Access Compliance Report

Public Rights-of-Way

(Curb Ramps)

Intersection ID: 45169	Main Street: HAZELVIEW_DR	Cross Street: LINDEN_TREE_LN	Location: NW
ADA ID: 04B159BF493F	Ramp Type: PerpDiag	Initial Pass/Fail: Fail	Overall Compliance: No
Severity Score: 33.75			
Codes/Mitigation Info/Possible Solution		Field Measurements/Component Compliance

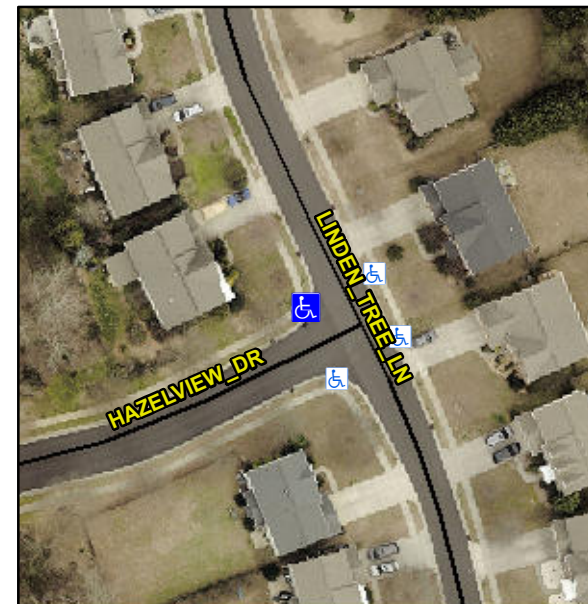
Not Found, R304.5.1, R304.5.3

Compliance	Description	Data	Compliance	Description	Data
N/A	Ramp Length (in)	47.0	Yes	Ramp Slope (%)	6.0
No	Ramp Width (in)	44.0	No	Ramp XSlope (%)	8.3
N/A	Flare Type LT	N/A	N/A	Flare Type RT	N/A
N/A	Flare Slope LT (%)	N/A	N/A	Flare Slope RT (%)	N/A
N/A	Flare Traversable LT?	N/A	N/A	Flare Traversable RT?	N/A
N/A	Landing Length (in)	N/A	N/A	DWS Provided?	N/A
N/A	Landing Width (in)	N/A	N/A	DWS Contrast?	N/A
N/A	Landing Slope (%)	N/A	N/A	DWS Length (in)	N/A
N/A	Landing X Slope (%)	N/A	N/A	DWS Full Width?	N/A
N/A	Landing Curb? (Y/N)	N/A	N/A	DWS Offset (in)	N/A
N/A	Shared Landing?	N/A			
N/A	Gutter Ponding?	N/A	N/A	Gutter Slope (%)	N/A
N/A	Gutter Lip Ht (in)	N/A	N/A	Gutter X Slope (%)	N/A
N/A	Painted X Walk1?	No	N/A	Painted X Walk2?	No
	X Walk 1 Direction	To S		X Walk 2 Direction	To E
N/A	X Walk 1 Width (in)	N/A	N/A	X Walk 2 Width (in)	N/A
	X Walk 1 Slope (%)	1.8		X Walk 2 Slope (%)	5.1
	X Walk 1 X Slope (%)	6.1		X Walk 2 X Slope (%)	0.7

Remove & Replace Curb Ramp With Two New Directional Ramps or Equivalent.
